T10/08-312 revision 0

Subject: SAS-2: Making 07-193 into an Annex

This is the re-creation of 07-193r1 putting it into a form that can be placed into the SAS-2 standard as an informative annex.

Figure 1 — Reference transmitter test load physical characterization

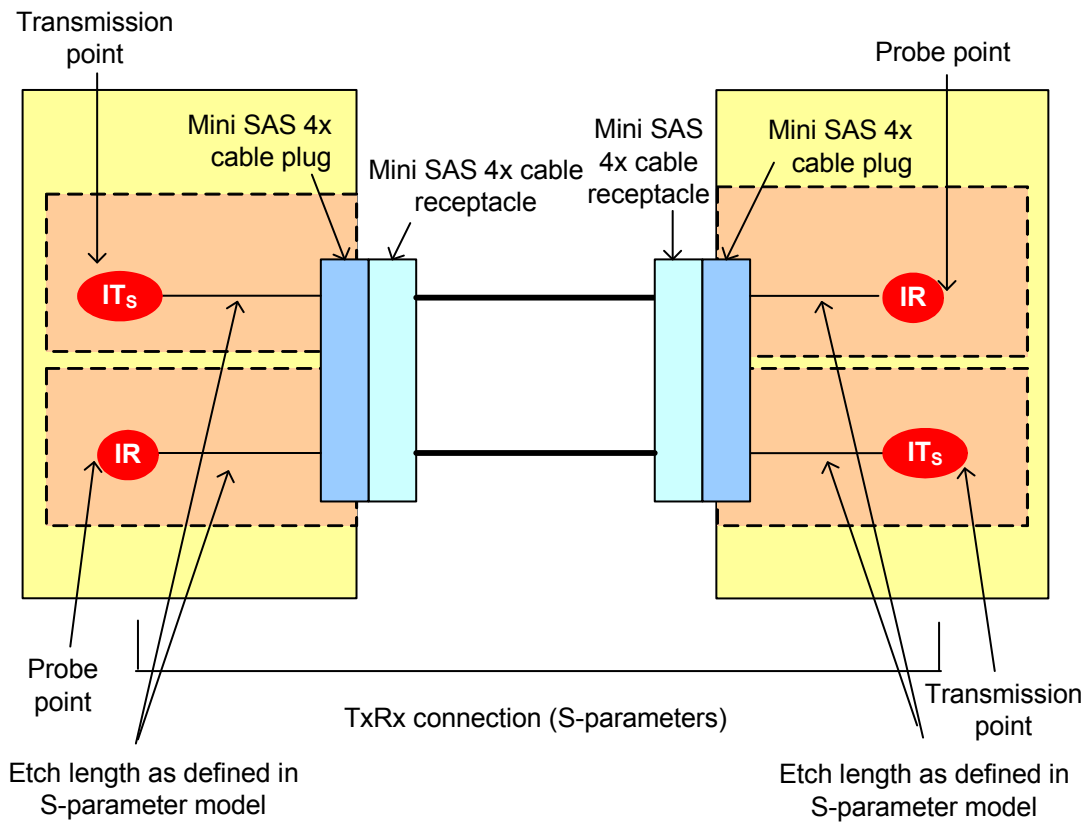
Figure 1 shows the physical model used to measure the reference transmitter test load. The etches between the transmission points and probe points may be included in an S-parameter measurement of a TxRx connection. Although these etches add extra loss to the TxRx connection, they are considered to be an

acceptable amount of loss for simulation purposes when restricted to a configuration similar to the reference transmitter test load.

Figure A.1 — S-parameter model of the reference transmitter test load

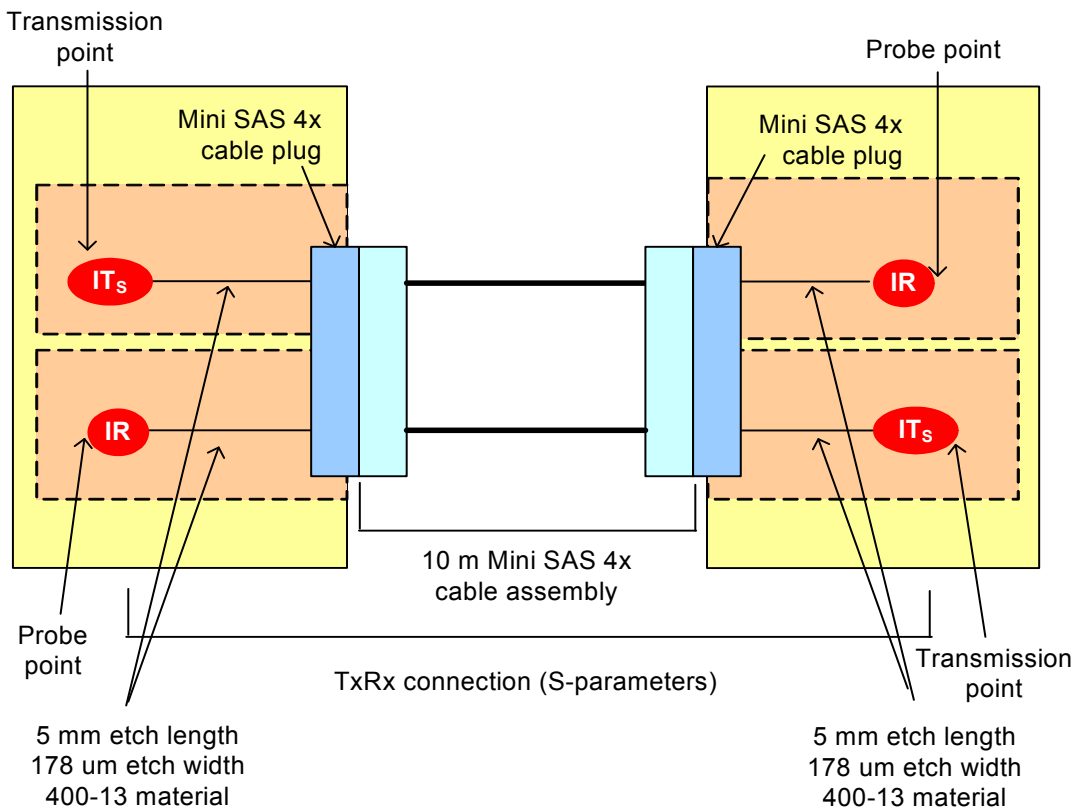
The S-parameter model of the reference transmitter test load consists of:

- a) an etch length of 50 mm with an etch width of 178 μm between the IT_s (see 5.3.6.5.4) and the SAS 4x cable plug (see figure A.1) in 4000-13 material environment;
- b) 10 m Mini SAS 4x cable assembly; and
- c) an etch length of 50 mm with an etch width of 178 μm between the IR (see 5.3.7.4.3) and the SAS 4x cable plug (see figure A.1) in 4000-13 material environment.

The following Touchstone® file containing the S-parameters of the reference transmitter test load is included:

- a) 07-193r1_SAS2_transmittertestload.s4p.

Figure A.2 — S-parameter model of the reference transmitter test load setup

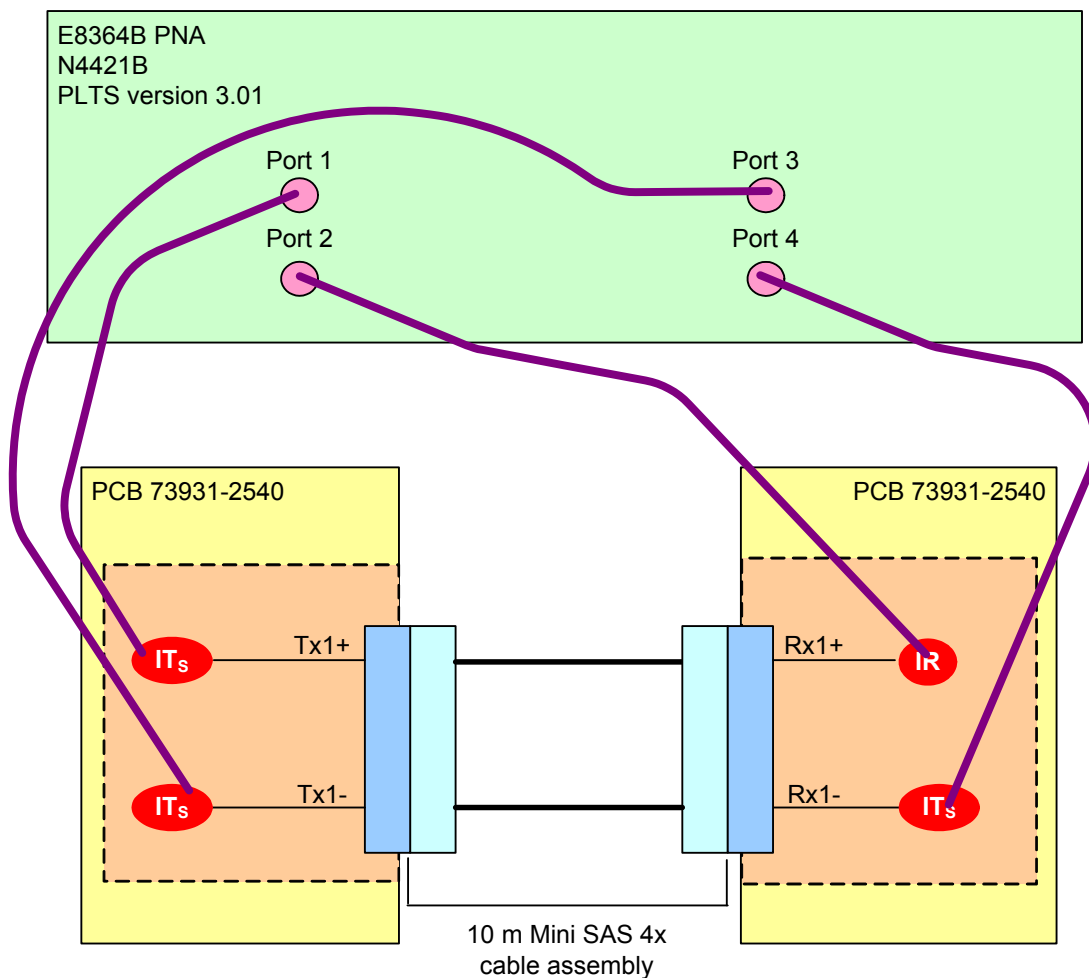
The following lists equipment that may be used to replicate the S-parameter model shown in figure A.1:

- Agilent E8364B PNA series network analyzer;
- Agilent N4421B s-parameter test set;
- Agilent Physical Layer Test System (PLTS) version 3.01;
- Molex 26-circuit External iPass™ Test Fixture (PCB 73931-2540); and
- 10 m Mini SAS 4x cable assembly.

The equipment is interconnected as shown in figure A.2.

Figure A.3 — Reference transmitter test load waveform

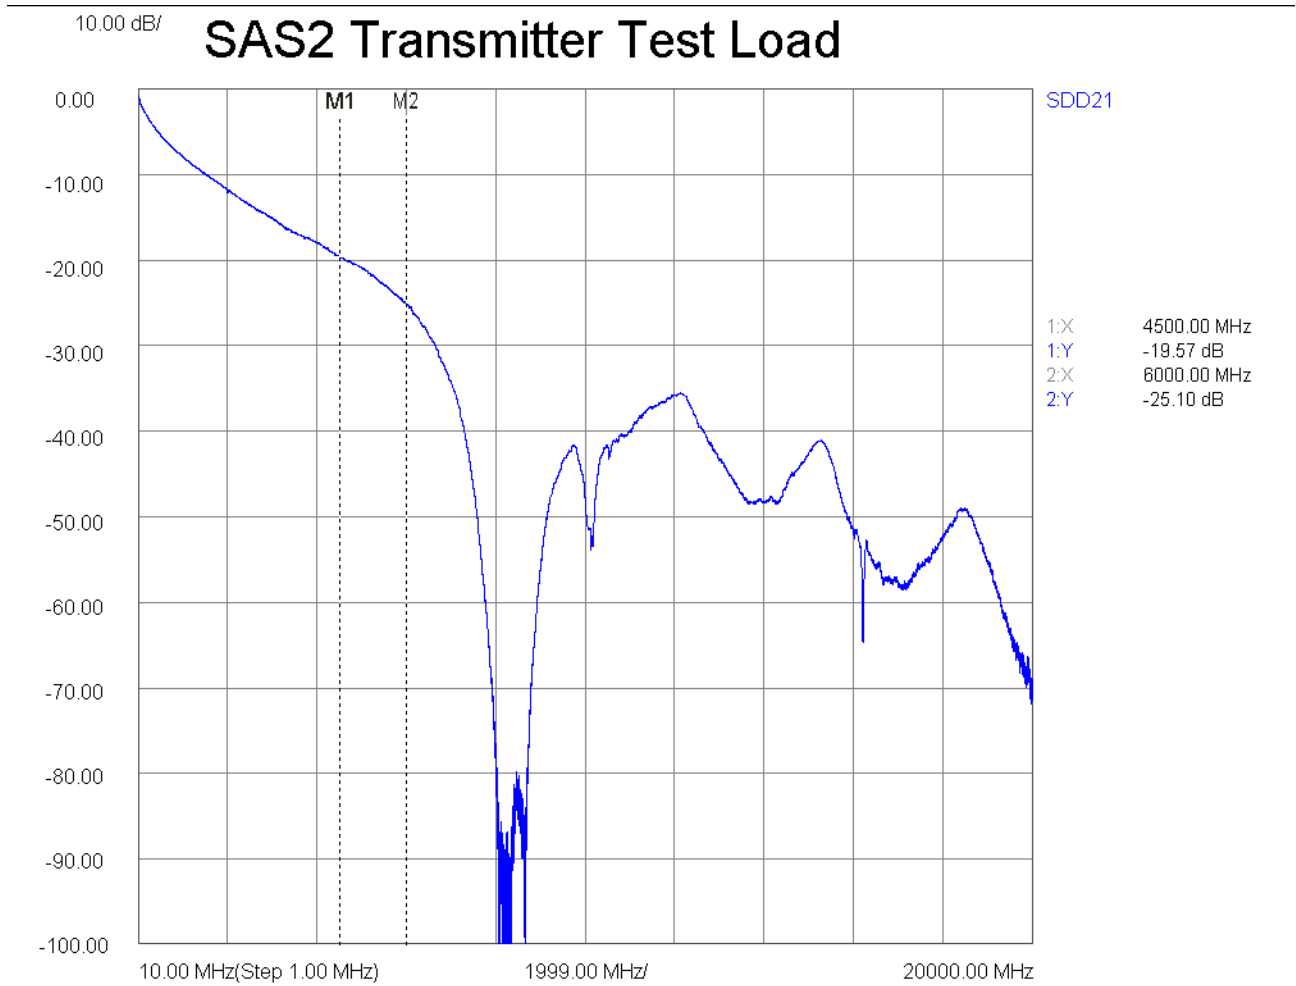
To generate the S-parameters for the reference transmitter test load sweep the Agilent E8364B PNA series network analyzer from 10 MHz to 20 GHz in 1 MHz steps. The result should be the waveform shown in figure A.3.
